MITSUBISHI SERVICE PUBLICATIONS TRANSMITTAL

SUBJECT: Goodrich Service Bulletin – Propeller De-Icer Timer Repair (SB 3E1150-30-01)

MODELS AFFECTED: All MU-2B Airplanes

PROPELLER DE-ICER TIMER REPAIR – GOODRICH P/N 3E1150-10 AND 3E1150-12

Figure 1: Propeller De-icer Timer Assembly

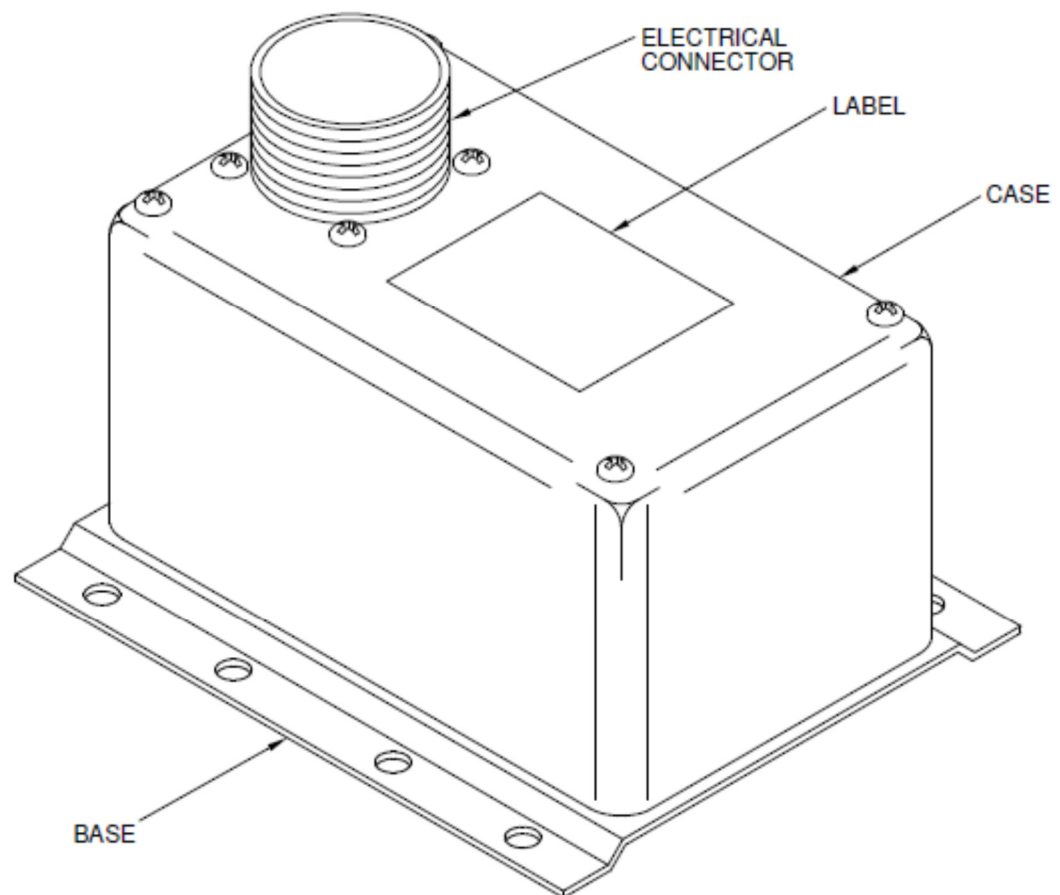
Some propeller de-icer timers may have experienced, or may be susceptible to experiencing failures due to a foam cushion, which may degrade over time in service. This Service Bulletin identifies actions necessary to:

- replace the foam cushion with a new cushion that will not degrade
- repair any damage that may have occurred due to the degradation
- apply protective coating to the printed circuit board to minimize the possibility of future malfunction.

This service bulletin introduces a repair that has been developed to replace degrading foam cushions and to clean and seal the circuit board that may have been affected by the degraded foam.

The repair consists of disassembly of the timer, and removal of the foam cushion. The printed circuit board assembly is cleaned of any residual foam, foam adhesives and any contamination due to the degraded foam. The cleaned printed circuit board is then conformal coated and a new foam cushion is installed. The timer is reassembled and a functional test is performed per the Returned Goods (RG) repair spec.

With reference to assembly drawing 4E2278, remove and discard foam cushion (item no 3). Clean the circuit board of foam residue or other contaminants.

Install new foam cushion, item no. 3, P/N 3K1451, per drawing 4E2278.

NOTE: Ensure that the new foam cushion is not trimmed when installed. The foam cushion is intentionally larger than the printed circuit and extends beyond the printed circuit board edge.
